12 November 2025

Council Reference: A006702114  
Attention: Kayal Chandrasekar

**RE: Request to make a ‘Minor Change’ under Section 81 of the Planning Act 2016 to a Development Approval – Material Change of Use and Building Works for a Multiple Dwelling (15 Units) at 3-9 Byron Street, Bulimba**

Figure 4: Proposed Ground Floor Plan (Source: MODE)

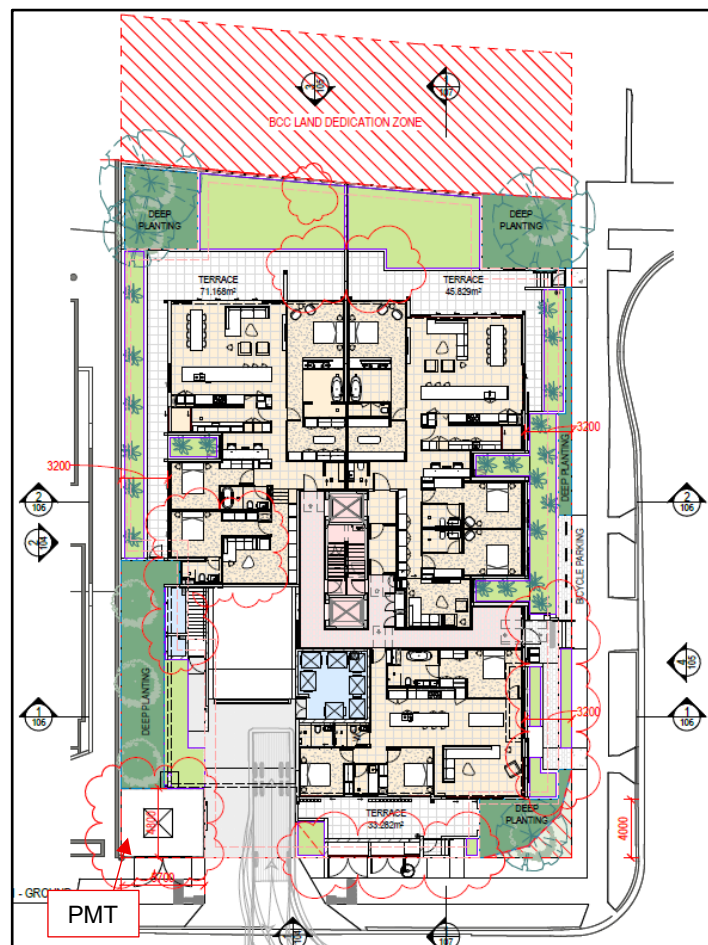
The PMT is proposed along the Byron Street frontage (south-western corner) and has been designed in consultation with the project’s electrical engineer to meet all service provider requirements (Figure 4). The PMT will be screened.

Subsequent amendments to the ground level are required to accommodate the PMT. These changes are detailed below.

Figure 5: Updated Swept Paths (Source: ITE Consulting)

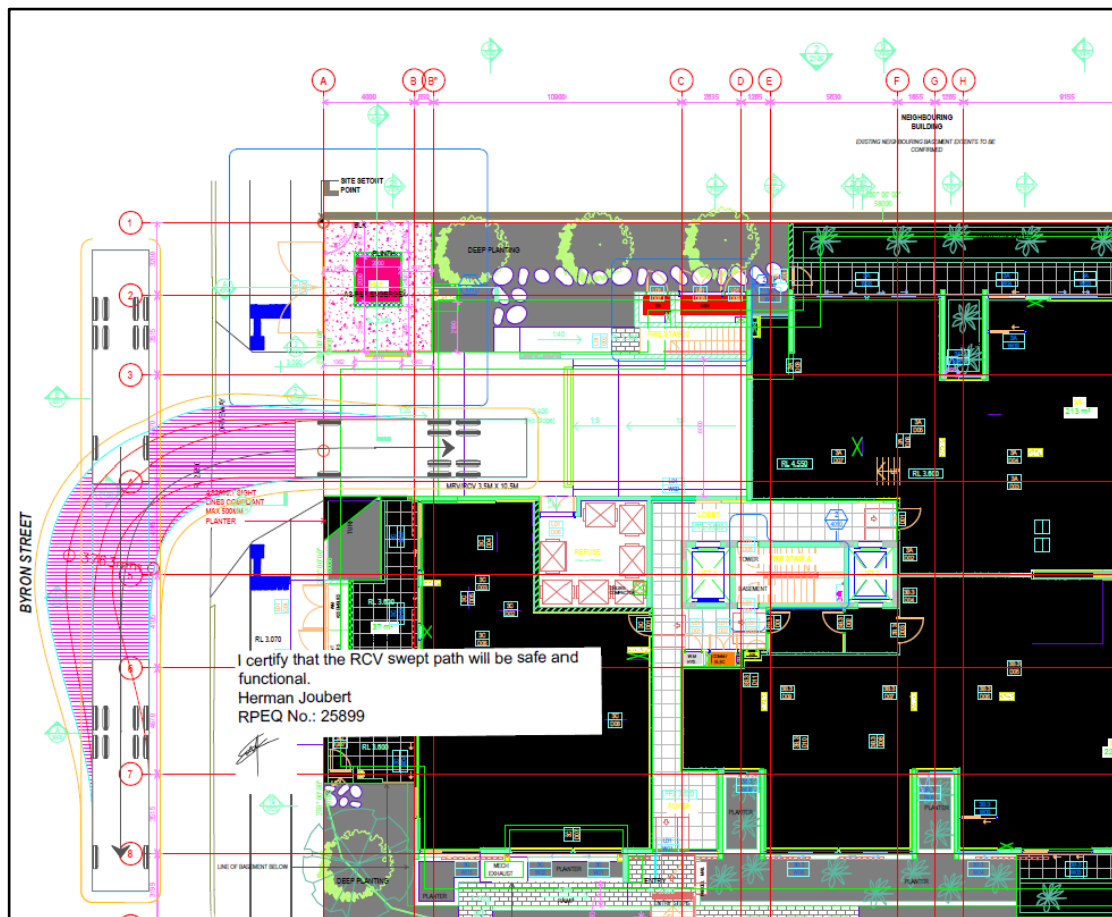
The PMT’s size and location will require a slight reduction in the driveway width from 6.5m to 6.2m and a minor reconfiguration of the vehicle crossover. As demonstrated within the Traffic Technical Note prepared by ITE Consulting, the development will maintain sufficient vehicle clearances and splays to accommodate servicing vehicles. Refer to Figure 5 below for updated swept paths.

Figure 6: Proposed Service Locations (Source: MODE)

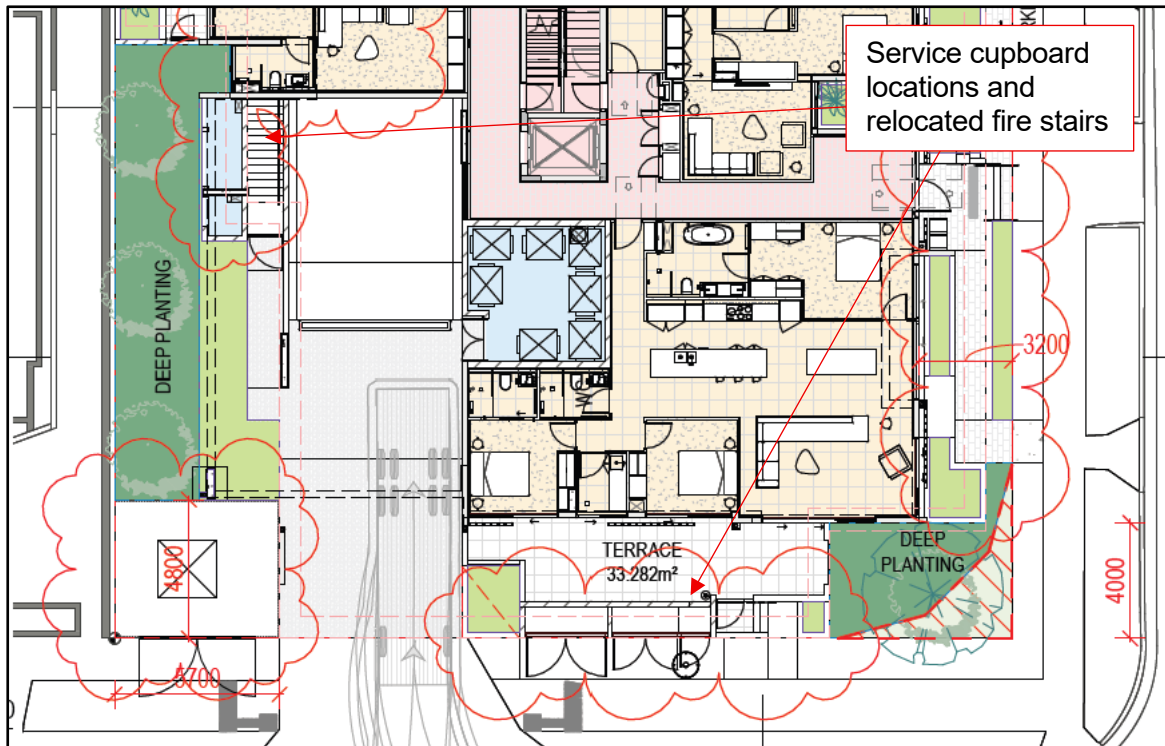
The introduction of the PMT and consultation with service providers has resulted in the relocation of certain building services to the Byron Street frontage and adjacent to the western boundary deep planting area (Figure 6 and 7). Further, the fire egress has been relocated further north, adjacent to the service cupboards.

Figure 7: Approved Ground Floor Plan (Left) vs Proposed Ground Floor Plan (Right) (Source: MODE)

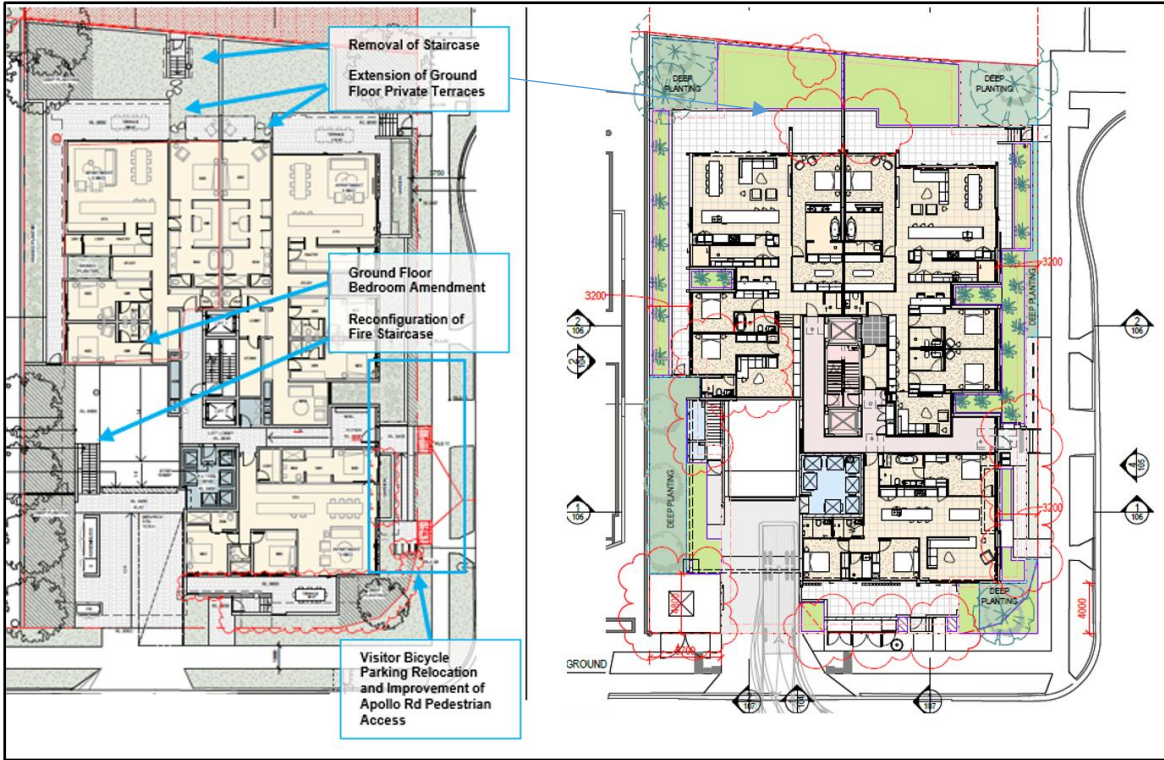
Minor amendments are proposed to the ground level units. These include:

- minor increase in GFA for the western unit where the unit extends further over the driveway ramp towards Byron Street (where continuing to maintain adequate vehicle height clearance)
- reconfiguring parts of the riverfront private outdoor space, where the outdoor terrace area will be increased in size and the approved stairway adjoining the waterway boundary removed due to security concerns.

The resultant proposed site cover remains consistent with the intended form and character of the area, supports outdoor sub-tropical living and maintains the approved articulation and modulation in the building form, as per PO8 of the Multiple Dwelling Code.

Figure 9: Approved Basement (Left) vs Proposed Basement (Right) (Source: MODE)

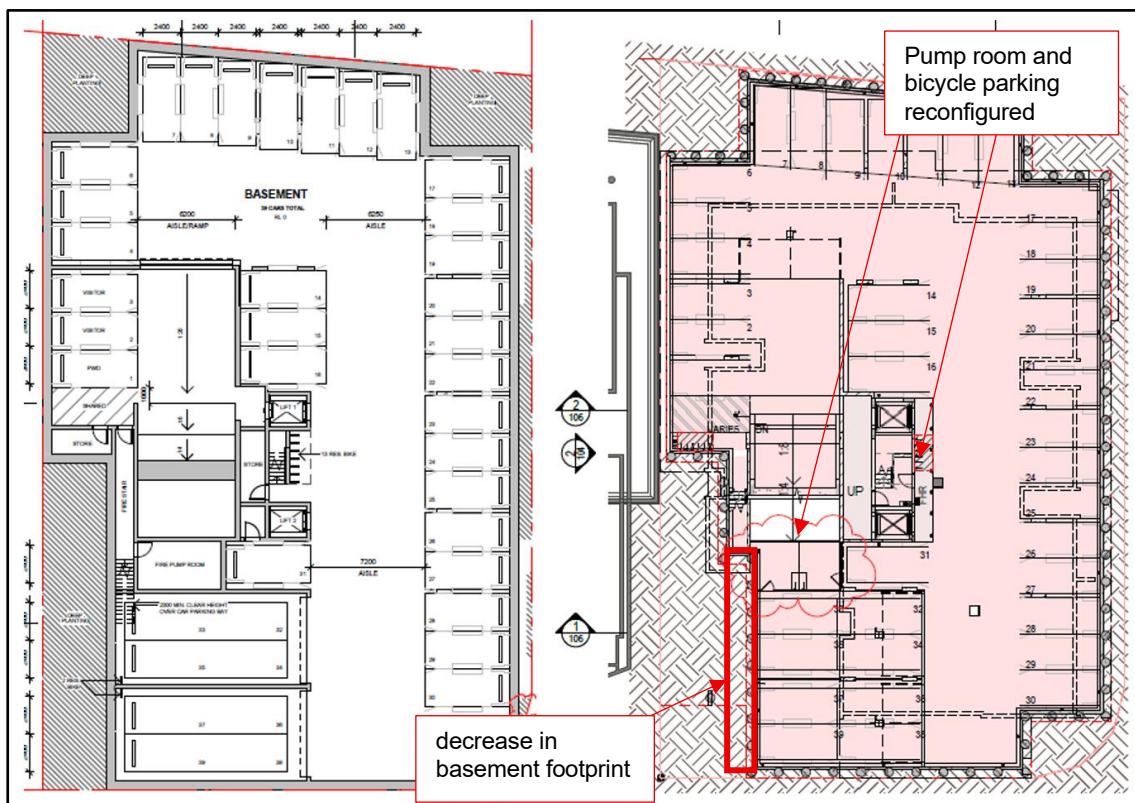
To account for services changes at ground level, the basement footprint has been marginally reduced, which has resulted in a minor reduction in the aisle widths and reconfiguration of the pump room and bicycle storage, to maintain sufficient car parking numbers (Figure 9). As demonstrate within the Traffic Technical Note prepared by ITE Consulting and Figure 10 below, the aisle widths are of a sufficient size to allow vehicle manoeuvring.

Figure 12: Proposed Floor Plans for Levels 2, 3 and 4 (Source: MODE)

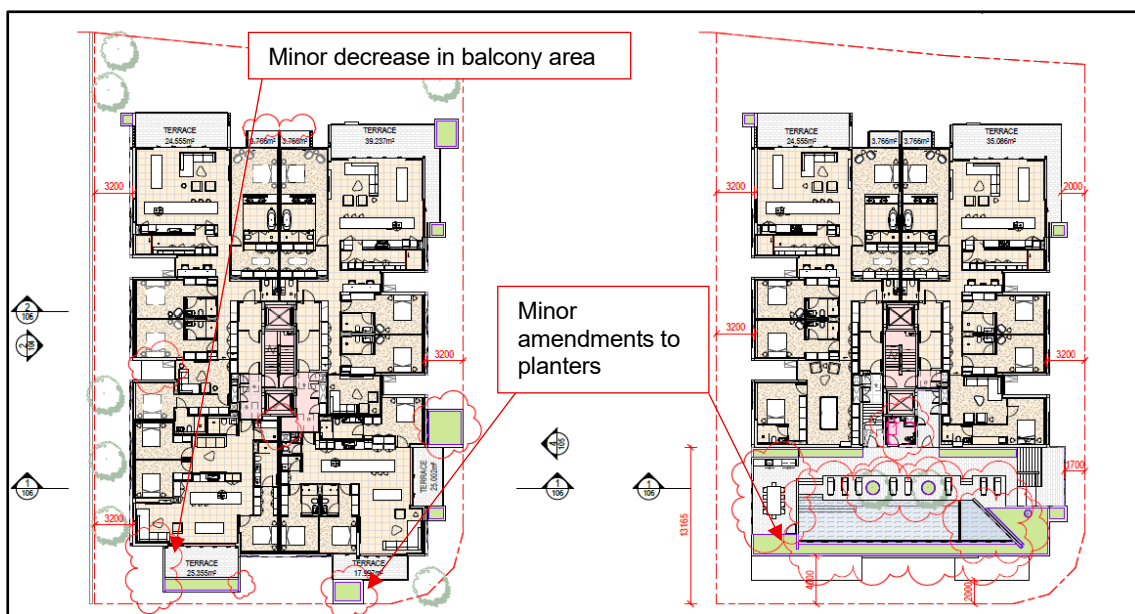
Minor reductions in the width of southern facing balcony areas are proposed for the units on Levels 2 and 3. Planning Scheme benchmarks related to balcony size and dimension are still achieved.

On Level 4, improvements have been made to the pool and communal open space. The approved BBQ/kitchen area has been relocated to accommodate the proposed communal powder room. The landscaping has also been slightly reduced to create room for a dining area near the BBQ/kitchen and increase the pool size —delivering a more functional dining and gathering space for residents.

As shown on the proposed plans and Landscape Concept Plans, some planters have been removed or reconfigured on the upper levels. In particular:

- Removal of planter in building break at western boundary for level 2 and 3

- Refinement to level 2 and 3 balcony planters facing Byron Street to better align with balconies
- Refinement to rooftop communal space planting to increase useability

Figure 13: Proposed Level 5 and Roof Level Floor Plans (Source: MODE)

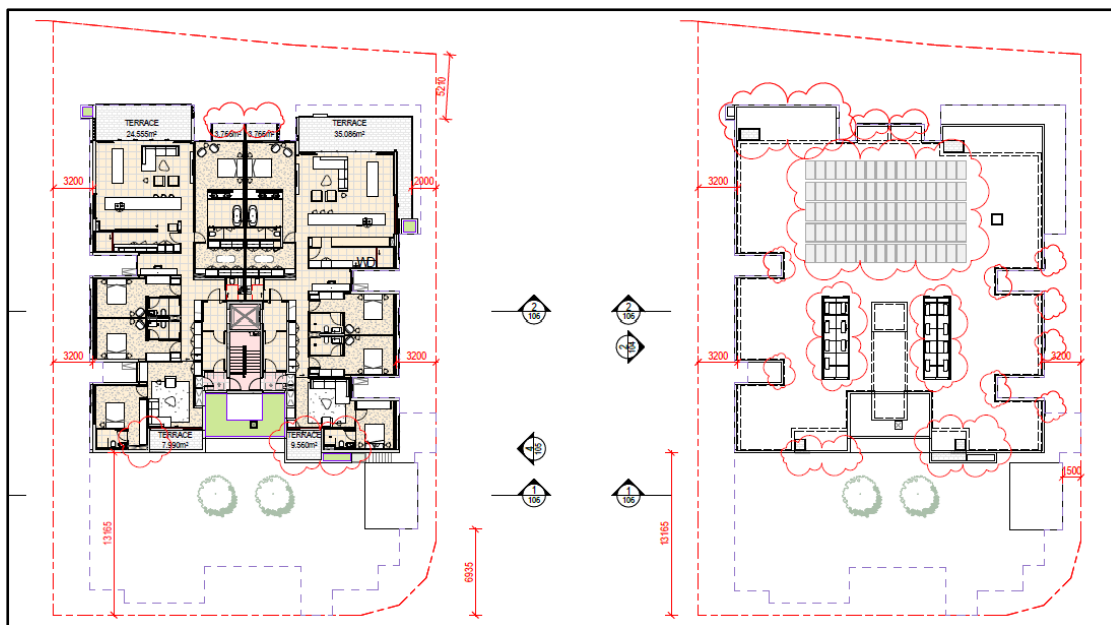
A minor layout change is proposed to the eastern unit at Level 5, with the ensuite now running parallel with Byron Street. This results in a minor reduction in the secondary balcony space fronting Byron Street (Figure 13). This proposed change does not result in an altered minimum setback to the balcony or wall. Further, the units are still afforded compliant private open space at the riverfront balcony.

Minor amendments have been made to the roof to accommodate screened air-conditioning units and solar panels. These rooftop services are ordinary components of multi storey buildings, and by way of their central, screened location, will not read as part of the main building envelope or contribute to any dramatic change to the approved building.
